PROJECT NAME: MULTI-FAMILY NW 57TH CT - 1 QUADRUPLEX

PROJECT NUMBER: 2025020048

APPLICATION: MINOR SITE PLAN #32505

TREES DESCRIPTION

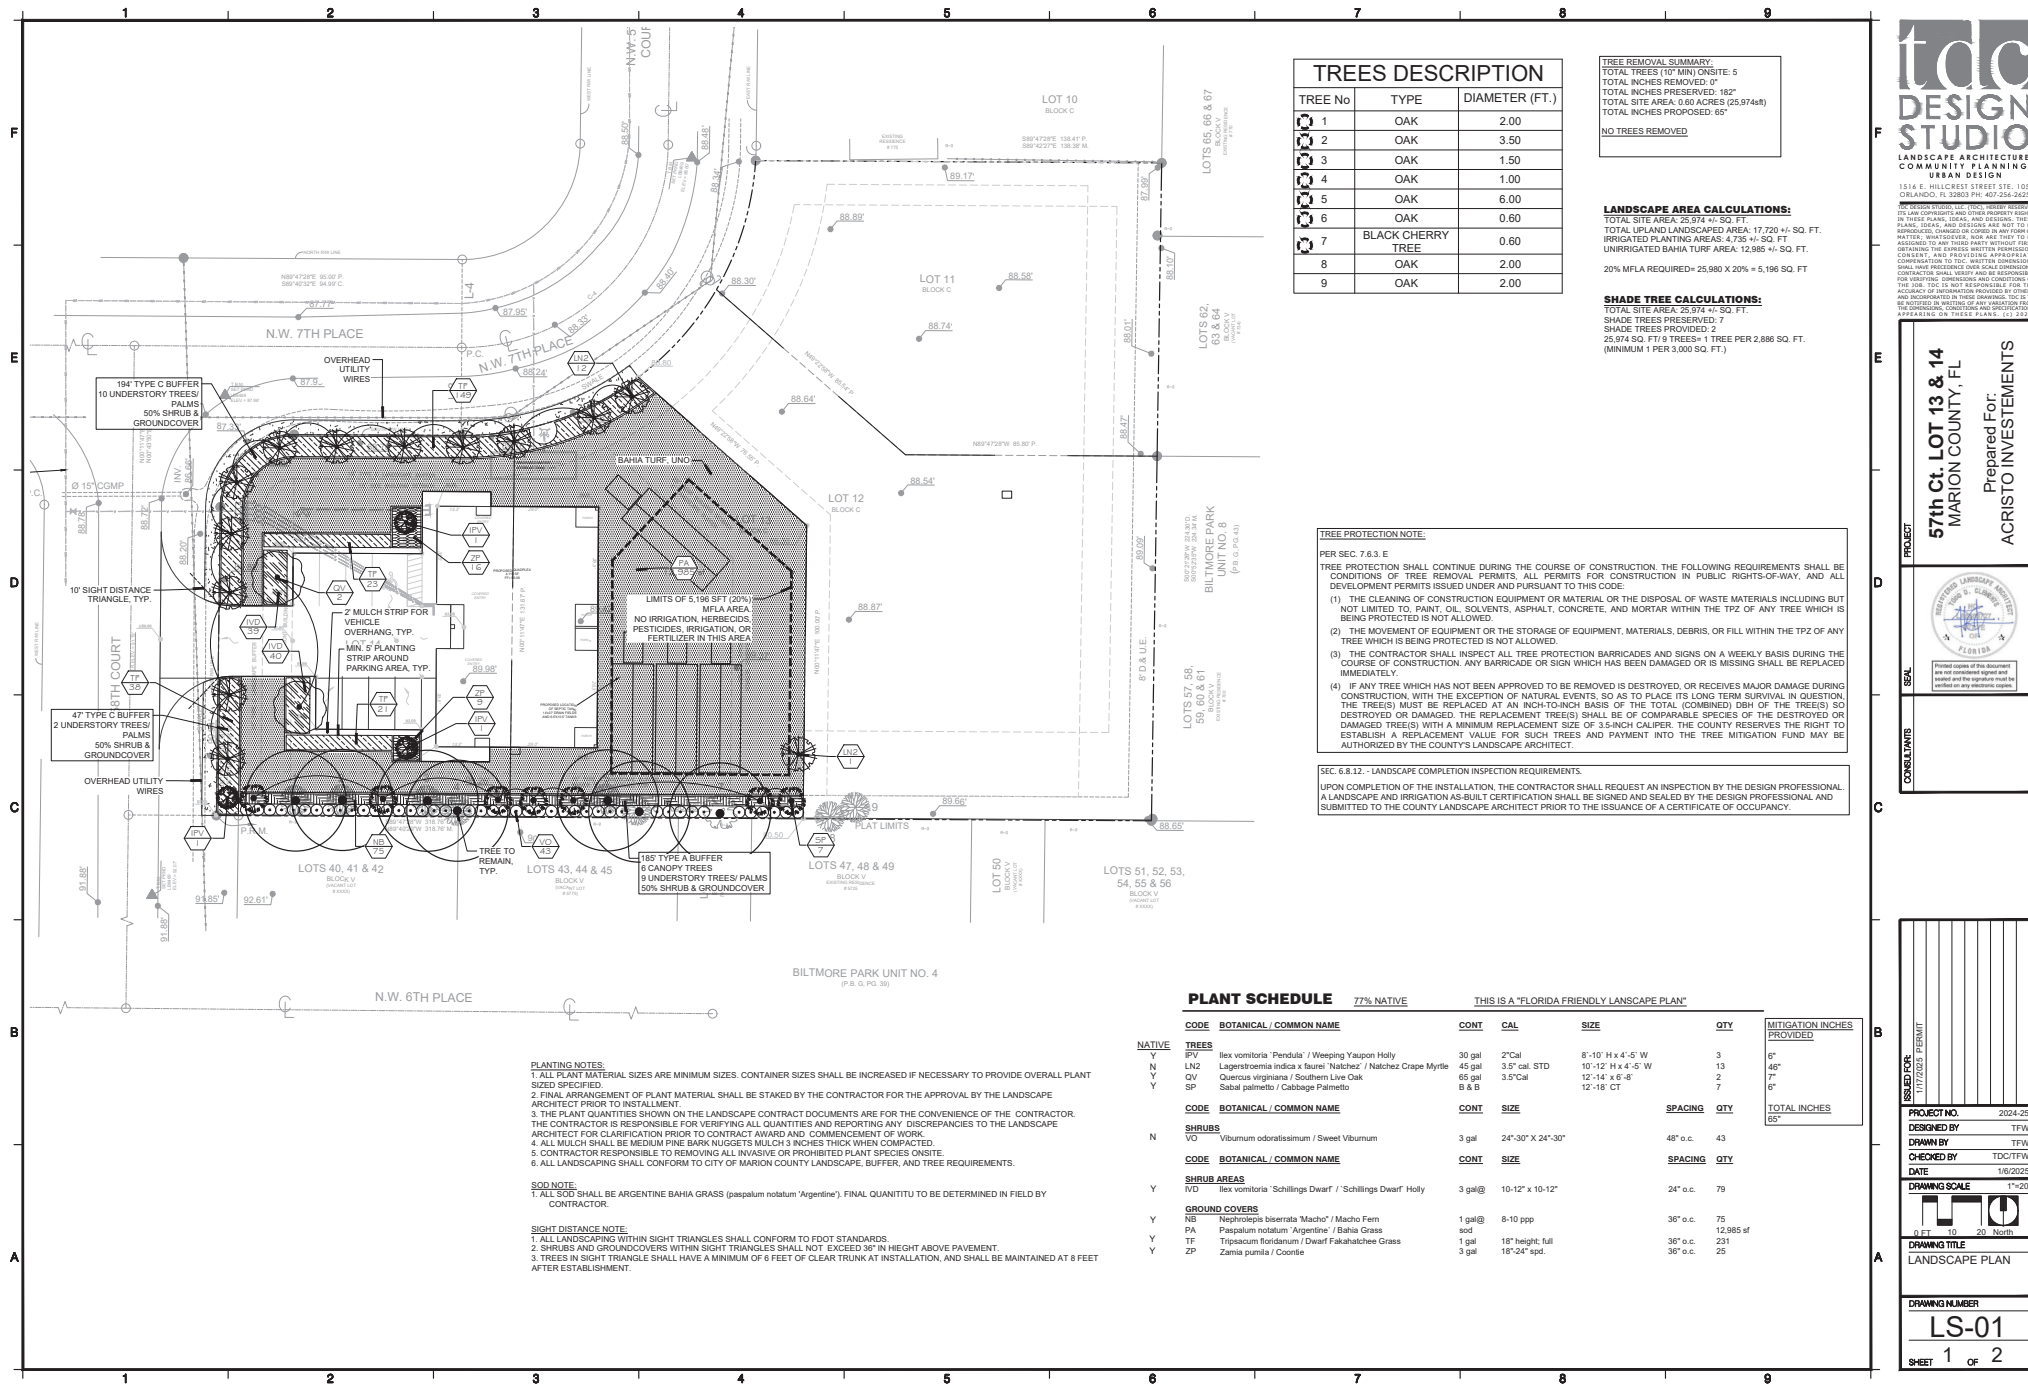
- 8 DEPARTMENT: LSCAPE - LANDSCAPE DESIGN AND IRRIGATION
REVIEW ITEM: 2.12.18 - All trees 10" DBH and larger
STATUS OF REVIEW: INFO
REMARKS: Tree diameter should be in inches, not feet
